This errata sheet provides information about known device issues affecting Stratix® V production devices.

Production Device Issues for Stratix V Devices

Figure 1. ATX PLL Left and Right Sides

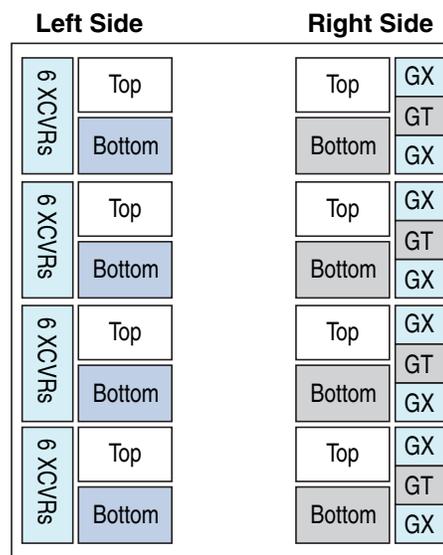
(2) Refer to Figure 1 for the Left side and Right side positions.

- (1) “L” is the post VCO Divider within the ATX PLL. The Local/Central Clock Divider is located within the channel.
- (2) Refer to Figure 1 for the Left side and Right side positions.

Range	Dividers (1)	Top ATX PLL in Transceiver Bank		Bottom ATX PLL Left Side in Transceiver Bank (2)		Bottom ATX PLL Right Side in Transceiver Bank (2)		Units
		Min Data Rate	Max Data Rate	Min Data Rate	Max Data Rate	Min Data Rate	Max Data Rate	
Native	L = 2	8,000	12,500	8,000	12,500	8,000	12,500	Mbps
/2	L = 4	4,000	6,600	4,000	6,600	4,000	7,050	Mbps
/4	L = 8	2,000	3,300	2,000	3,300	2,000	3,525	Mbps
/8	L = 8, Local/Central Clock Divider = 2	1,000	1,650	1,000	1,650	1,000	1,762.5	Mbps

Range	Dividers (1)	Top ATX PLL in Transceiver Bank		Bottom ATX PLL Left Side in Transceiver Bank (2)		Bottom ATX PLL Right Side in Transceiver Bank (2)		Units
		Min Data Rate	Max Data Rate	Min Data Rate	Max Data Rate	Min Data Rate	Max Data Rate	
Native	L = 2	8,000	12,500	8,000	12,500	8,000	12,500	Mbps
/2	L = 4	4,000	6,600	4,000	6,600	4,000	6,600	Mbps
/4	L = 8	2,000	3,300	2,000	3,300	2,000	3,300	Mbps
/8	L = 8, Local/Central Clock Divider = 2	1,000	1,650	1,000	1,650	1,000	1,650	Mbps
